ENGINEERING CHANGE PROPOSAL, PAGE 1
(SEE MIL-STD-480 FOR INSTRUCTIONS)

1. MODEL/TYPE Block 5D-3	2. MFR CODE 49671	3. SYSTEM DESIG. DMSP	4. ECP NO. 71R1	5. TYPE F	6. REV. 1	7. CORR. N/A	8. BASELINE AFFECTED <input type="checkbox"/> FUNCTIONAL <input type="checkbox"/> ALLOCATED <input type="checkbox"/> PRODUCT

a. SYSTEM		See Attach. 1-5.					N/A		
b. ITEM		See Enclosure 1.					N/A		
c. TEST PLAN		N/A					N/A		
12. TITLE OF CHANGE Realtime Data Smooth Implementation								13. CONTRACT NO & LINE ITEM F04701-89-C-0029

Realtime Data Smooth Implementation
(S16-S20)

Figure 16.3.1- 1 Realtime Data Smooth Block Diagram (S16)

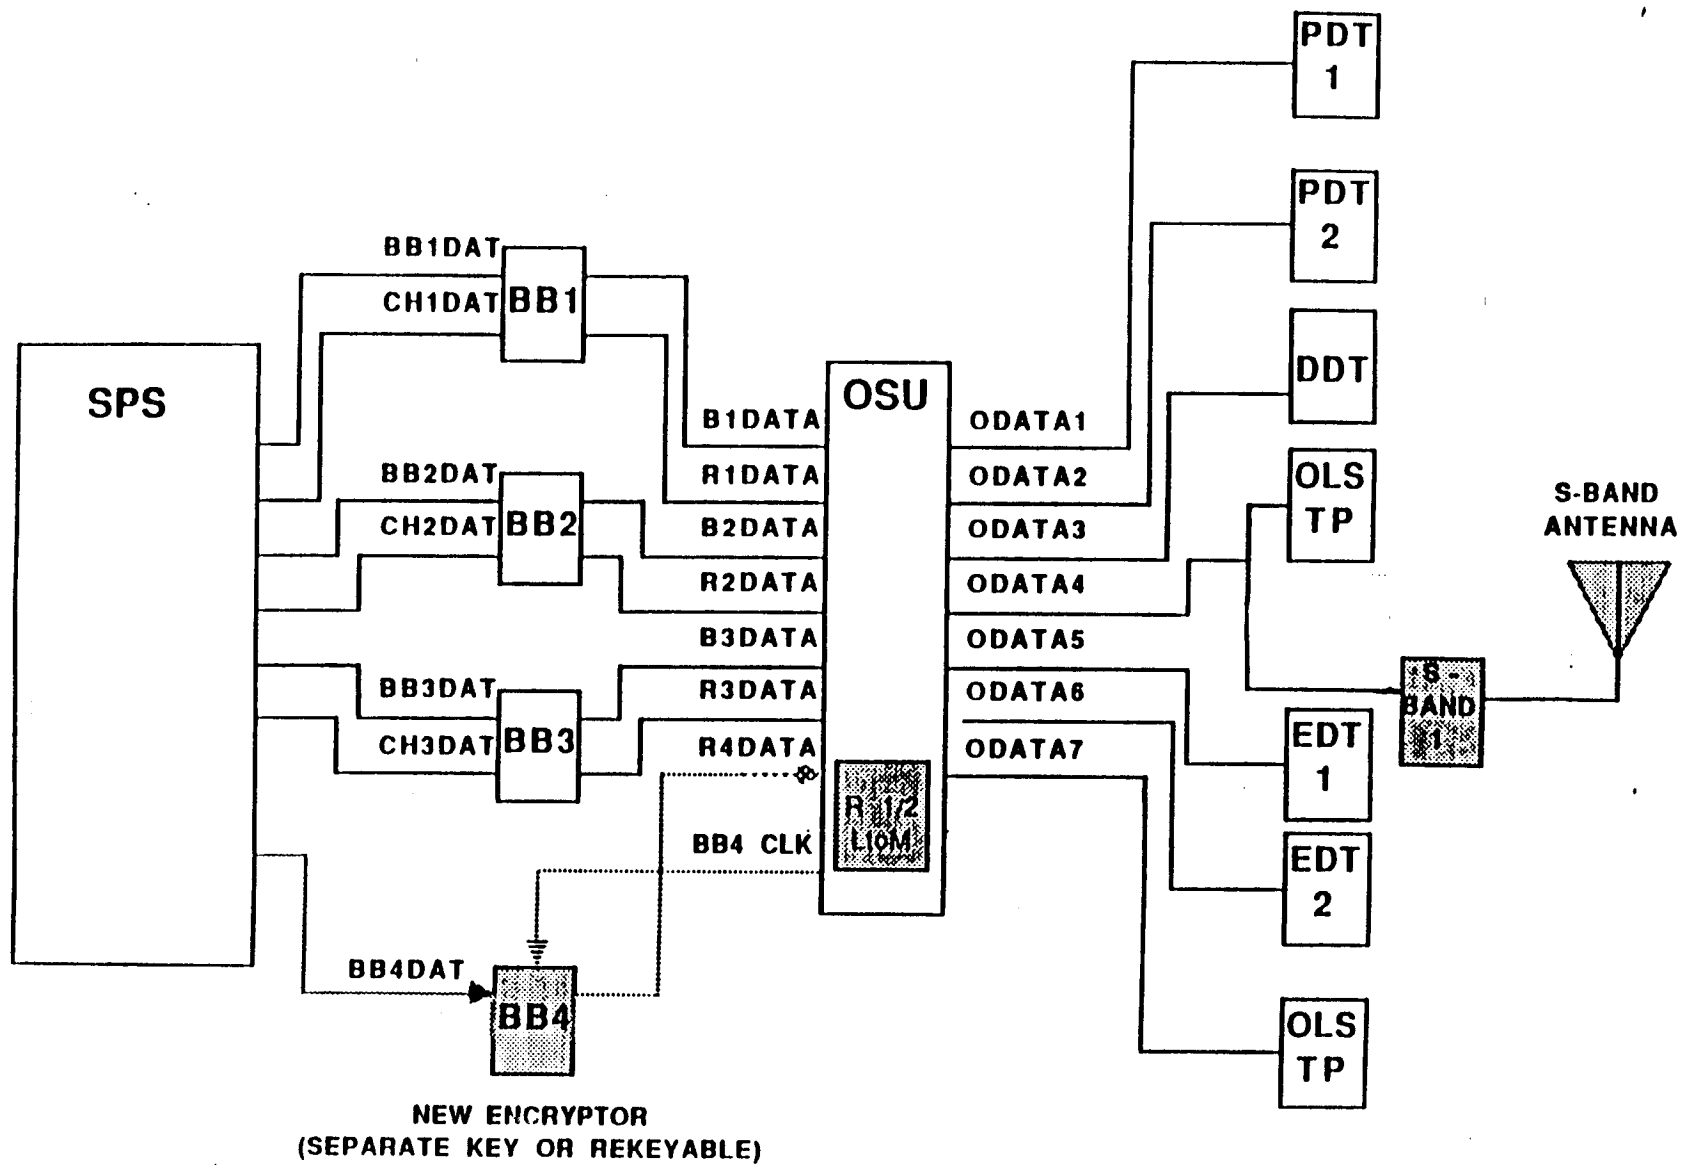
The RDS data will be routed to an S-band transmitter on S16, as shown in Figure 16.3.1-1, and to both an S-band transmitter and also a pair of redundant UHF transmitters on S17-S20, as shown in Figure 16.3.1-2. The output of the selected UHF transmitter of each pair will be coupled through an RF switch to an antenna.

Figure 16.3.1-2 Realtime Data Smooth Block Diagram (S17-S20)

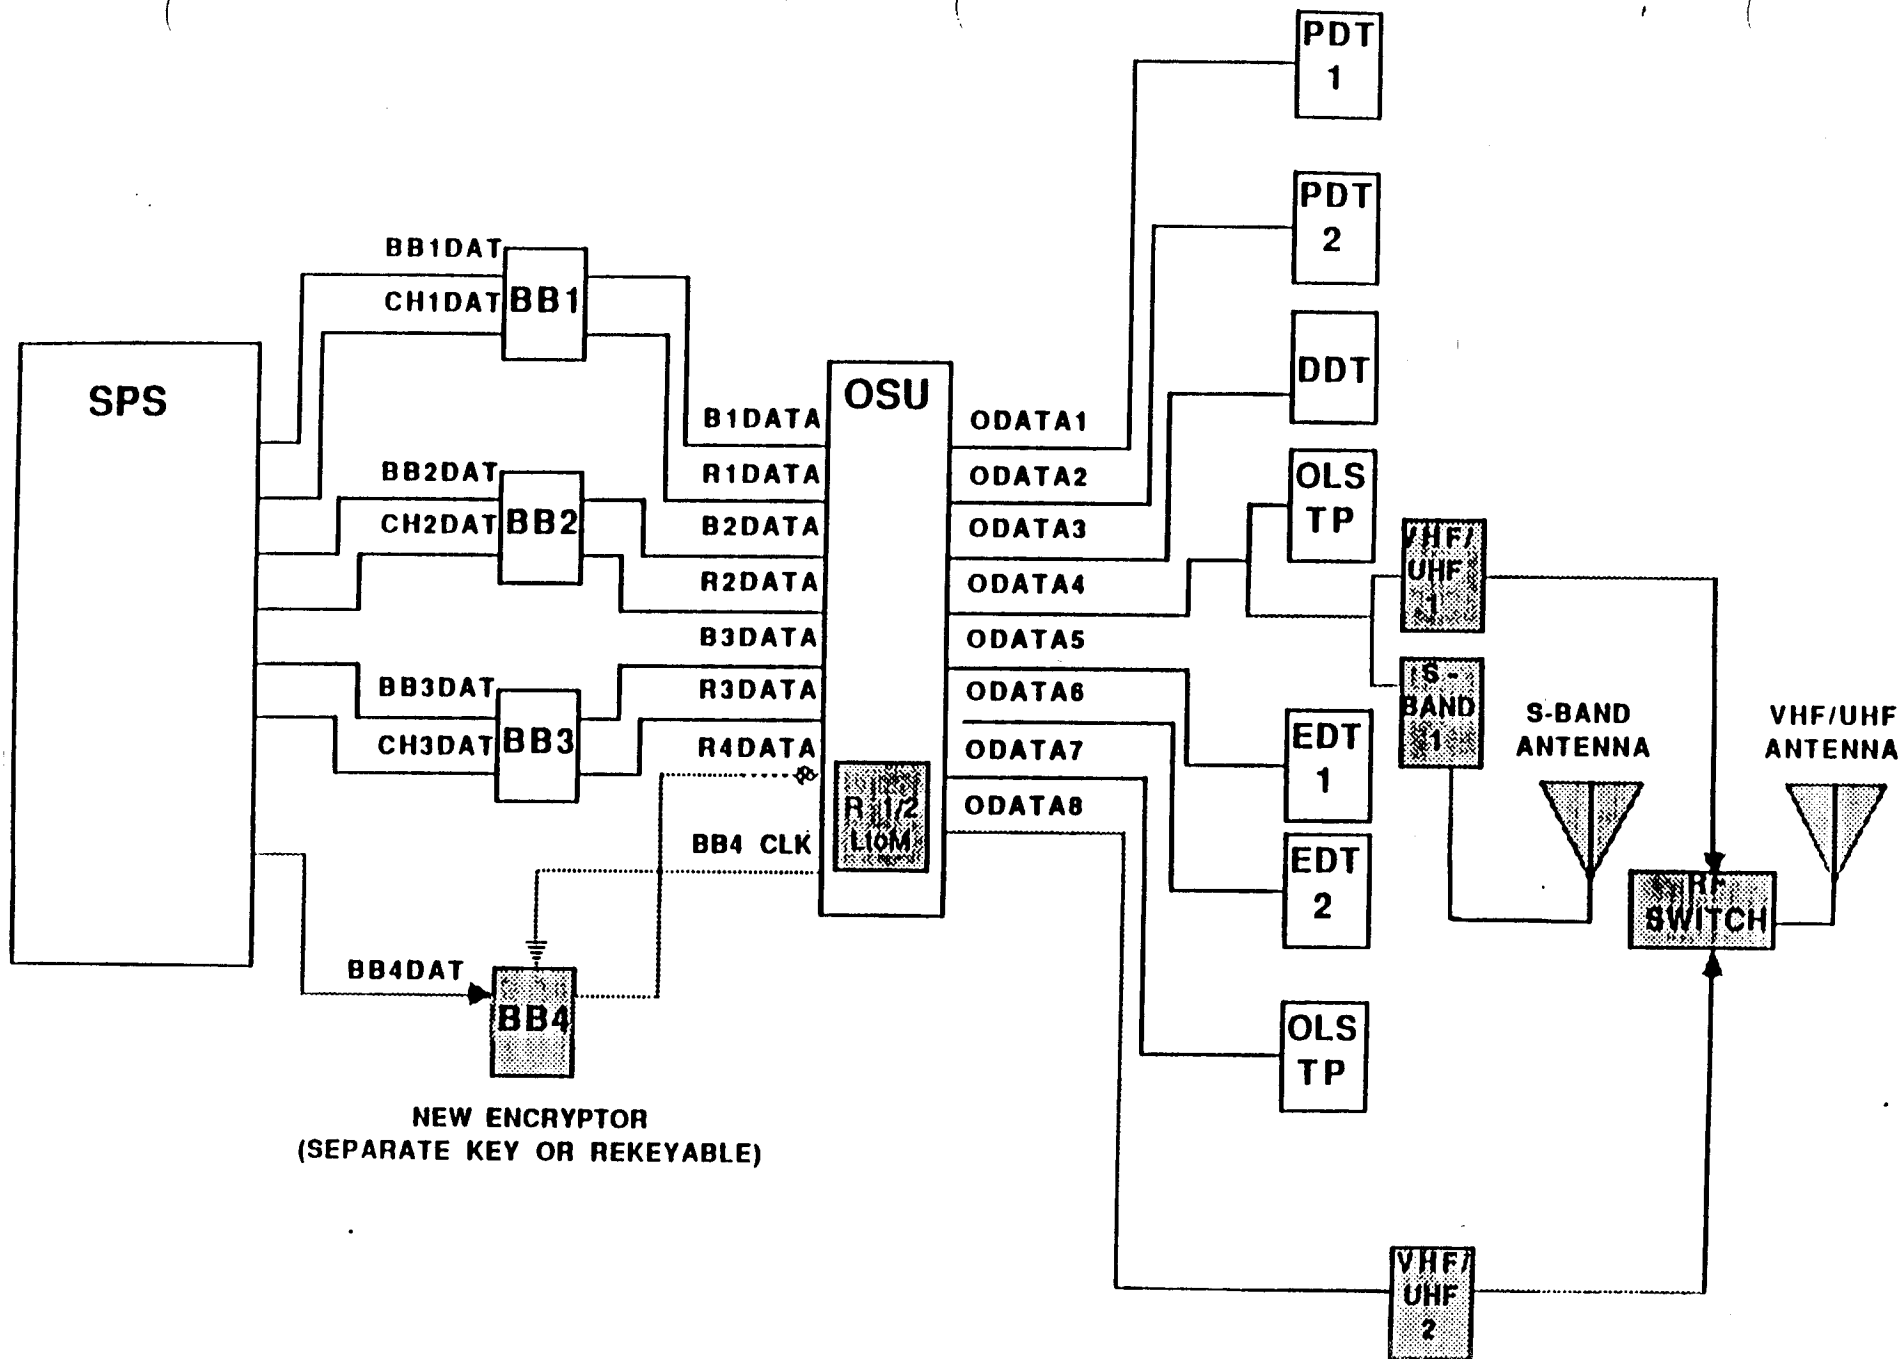
On S17-S20, the RDS data will also be furnished to two functionally redundant UHF transmitters operating at two different carrier frequencies. For the purposes of this proposal, carrier frequencies in the vicinity of 400 MHz have been assumed.

The output of one of the two S17-S20 UHF transmitters (selectable by command) will be routed via an RF switch to a single omnidirectional antenna. The proposed RF switch is presently used on the TIROS spacecraft. The RF switch will be purchased from Transco Products, Inc.

Figure 16.3.3-1 Analog Telemetry Format

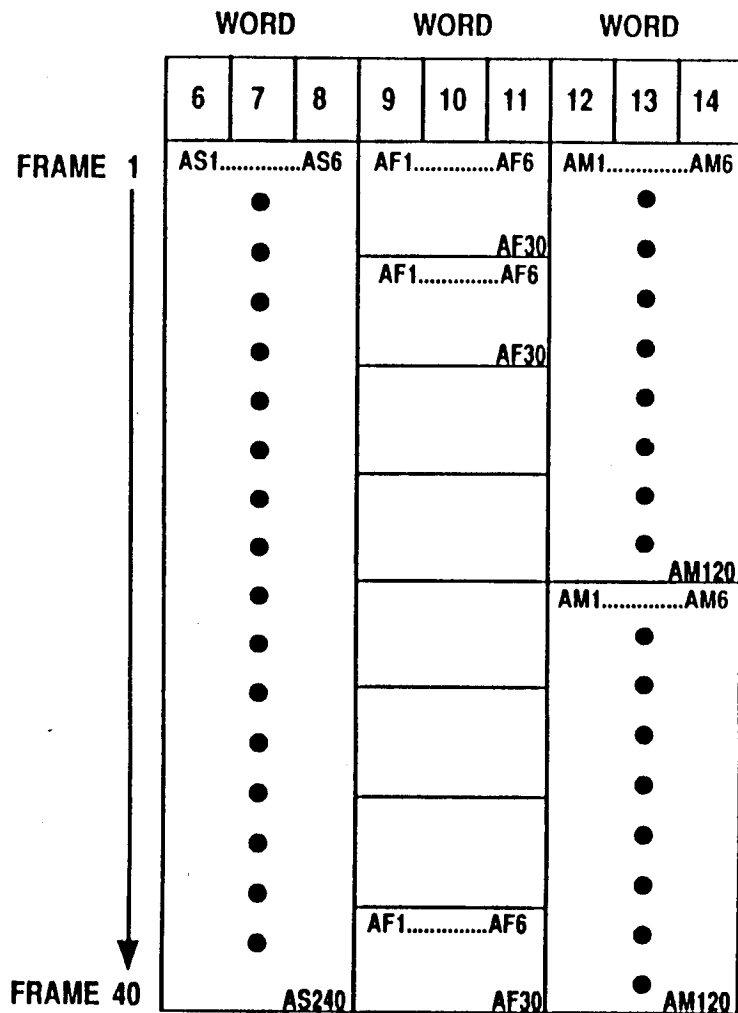
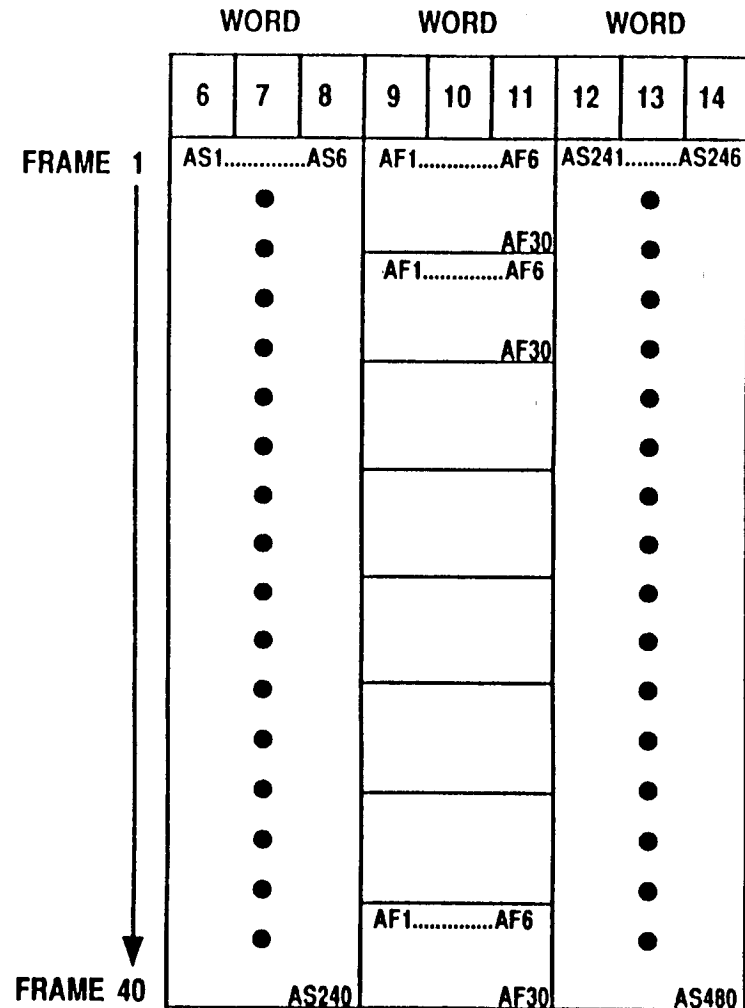
The PIP will be modified to expand the number of analog input channels from 384 to 512. The current PIP design has no spare analog channels to accommodate telemetry signals from the additional transmitters and encryption unit. There are sufficient spare discrete signals. An additional analog multiplexer board will be added to a spare slot in the PIP container. Analysis of the existing DC/DC converter shows that this subassembly will require redesign to increase its capacity to handle the outputs of the additional multiplexer chips. The PIP container will not need

The PIP firmware will also be modified to allow processing of the new analog channels. The firmware modifications will be limited to the replacement of the medium time commutated telemetry readout (TCTR) samples with a second set of slow TCTR samples. This second slow TCTR table will be the same size as the original slow TCTR table. This enables processing of the additional 120 analog signals. The frame format will change slightly, since all the medium slots will be replaced with slow slots. The length, timing, and rate of the telemetry frames will not change.

Figures 16.3.3-1 and 16.3.3-2 depict the proposed PIP frame format.

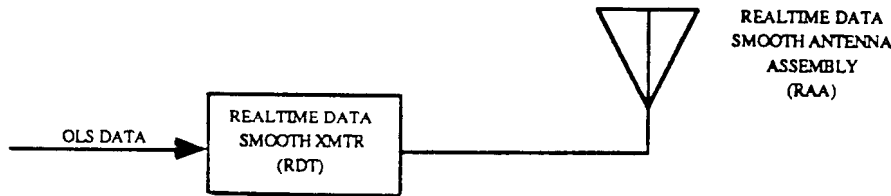
4. Page 16b, include Figure 5 from S-DMS?-895 with the following addition in the block called "Communications Group,":

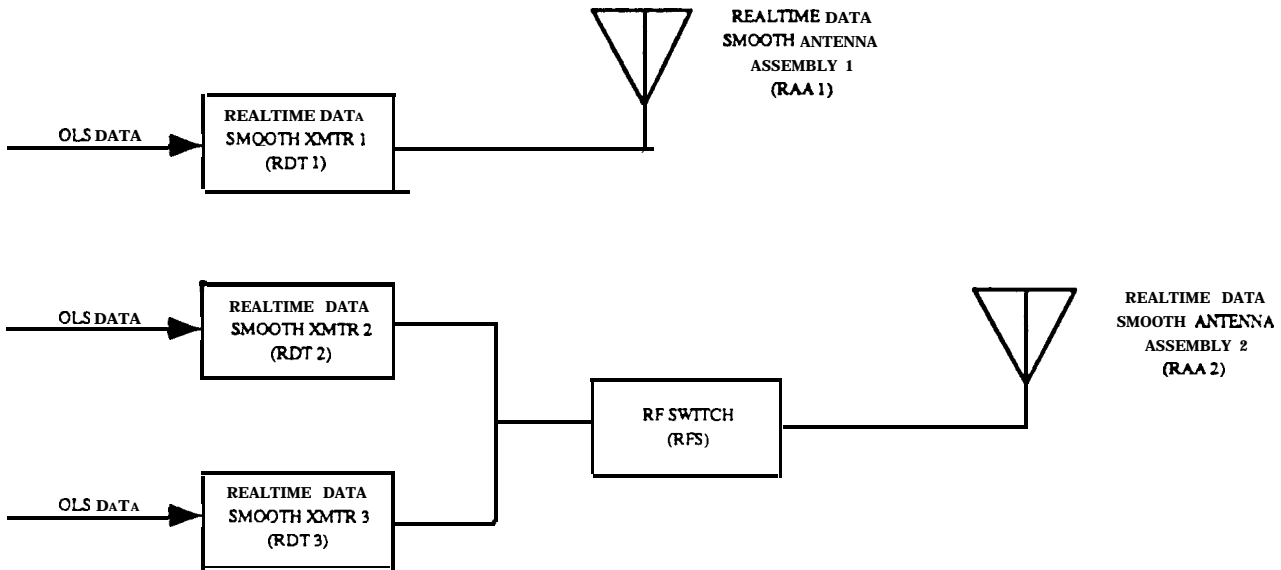
4. Page 16b, include Figure 5 from S-DMSP-895 with the following additions in the block called "Communications Group,":

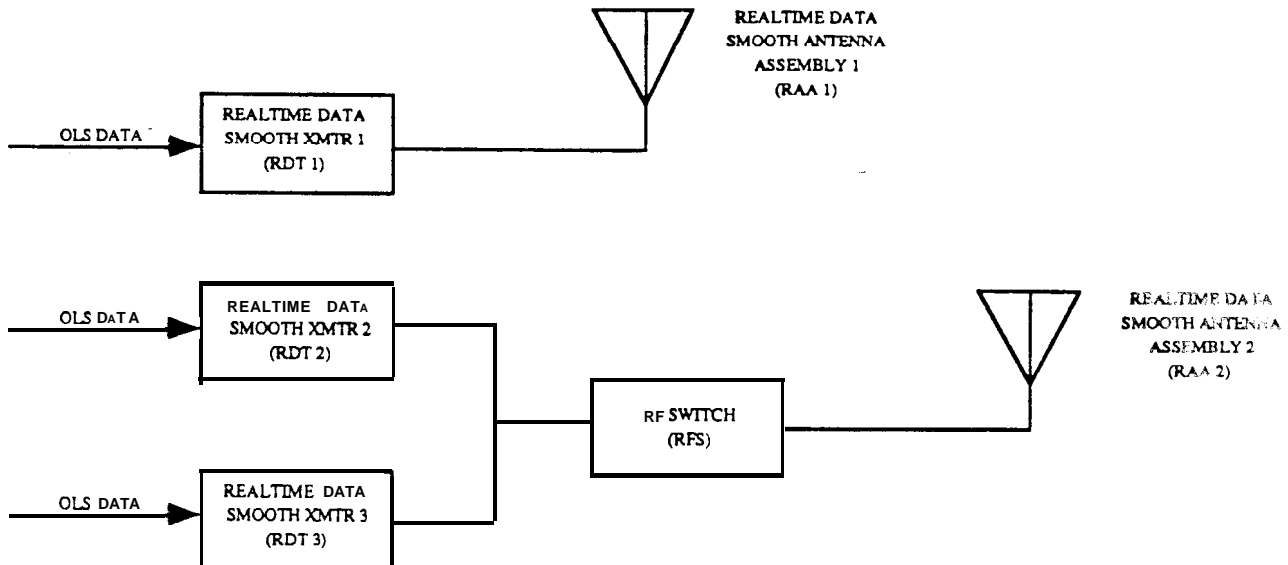
4. Page 16b, include Figure 5 from S-DMSP-895 with the following additions in the block called "Communications Group,":

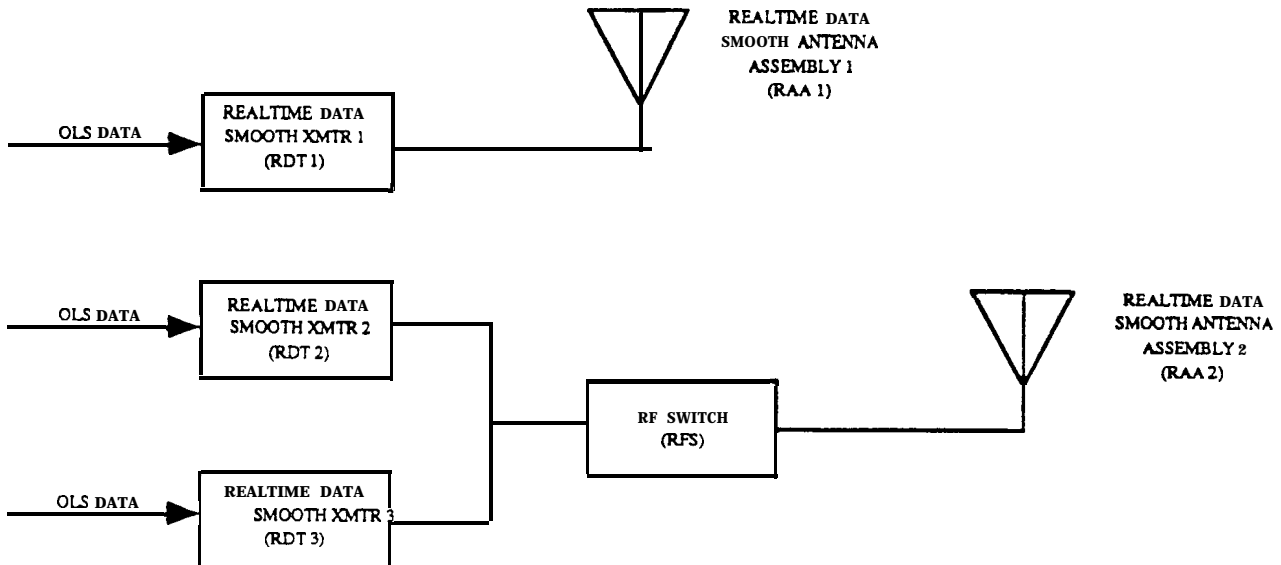
4. Page 16b, include Figure 5 from S-DMSP-895 with the following additions in the block-called "Communications Group,":

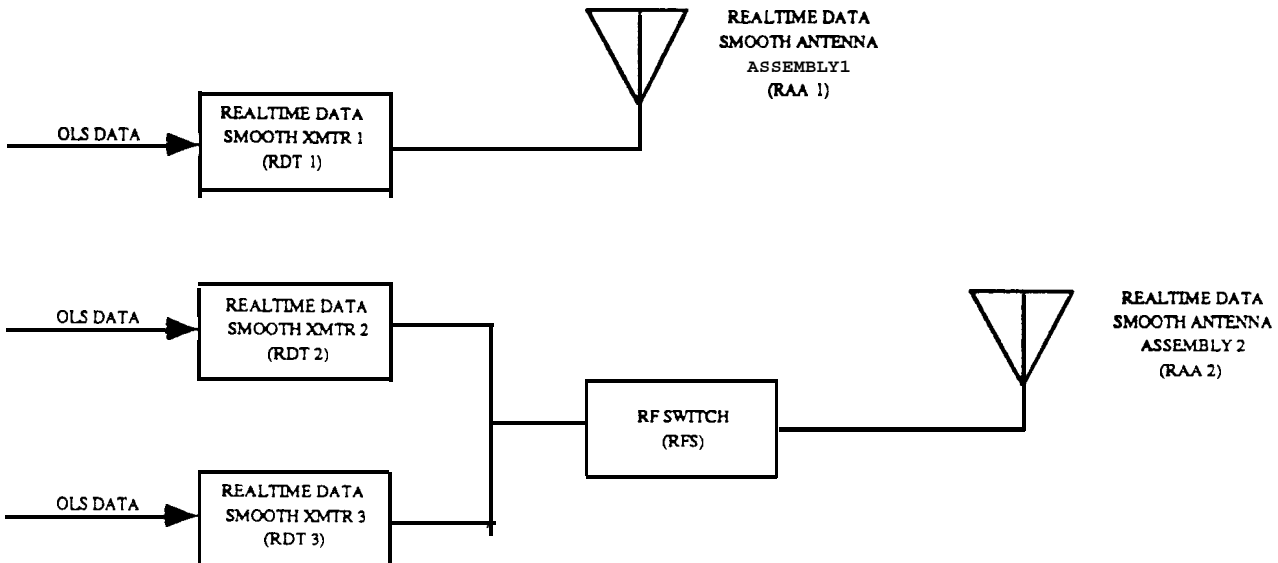
4. Page 16b, include Figure 5 from S-DMSP-895 with the following additions in the block called "Communications Group,":
